Comment on gmd-2021-235

Anonymous Referee #1

Summary:

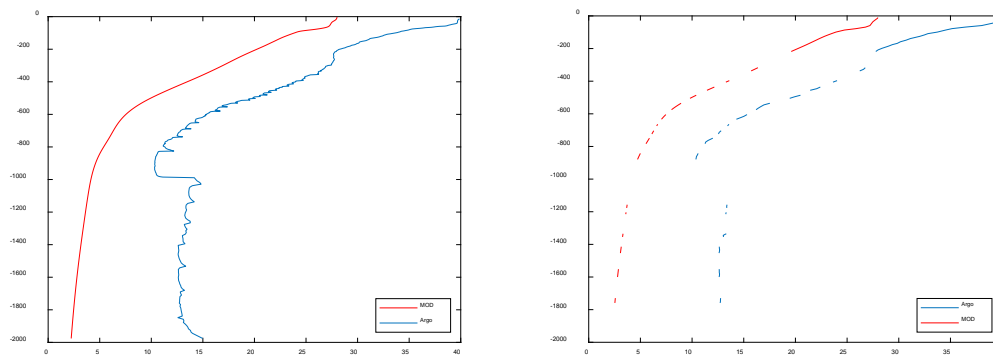
11 Figure 13: Why the RMSE of temperature is suddenly large in June in Fig. 13b? In the paper of a recently published paper (Ding et al., 2021), there is also a similar large bias in June, can you provide some explanations to this?

Thanks for pointing out this issue. We have checked the original data in detail, and found that there were two Argo temperature profiles with bad quality as shown in following figures. The temperature observation is almost 40 °C at surface, and more than 10°C below 1000m layer. We have removed the two profiles, recalculated RMSE and replotted the figure 13b. We are sorry about this.
